EXHIBIT H - CONDITIONS OF APPROVAL

DRB Recommended Conditions of Approval:

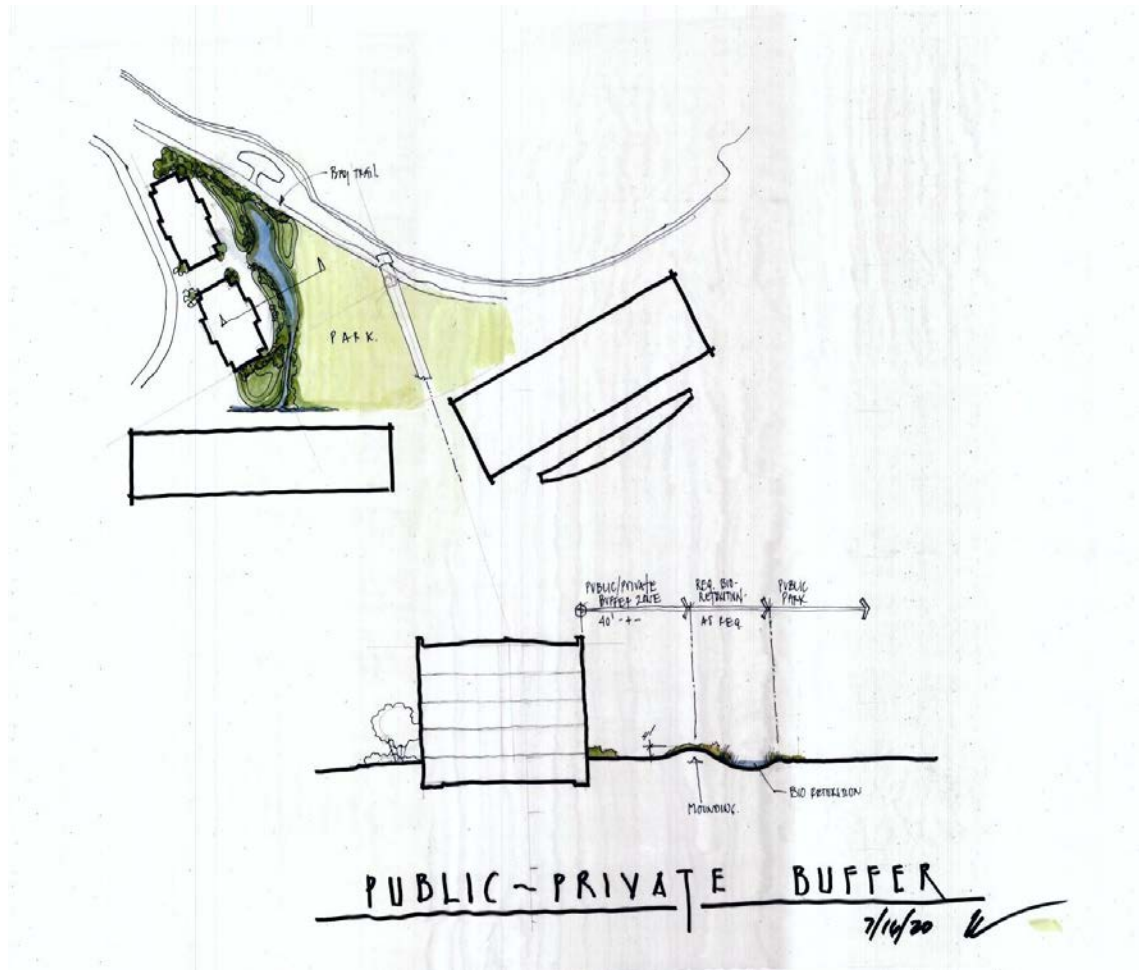
7. **Supplemental information** that was attached to the DRB on 7-21 via email from Staff shall be adopted into the Design Guidelines including option B of the shoreline park.
8. **Public private buffer zone:** When a public park-interfaces with a private

residential zone, a buffer zone shall be established at the ground floor. The dimension of this zone will vary with the site but at no time shall it be less than 20 feet. This buffer can be inclusive of required setbacks. A visual break consisting of landscaped berms or dense landscaping or landscape wall shall be considered. See example below.
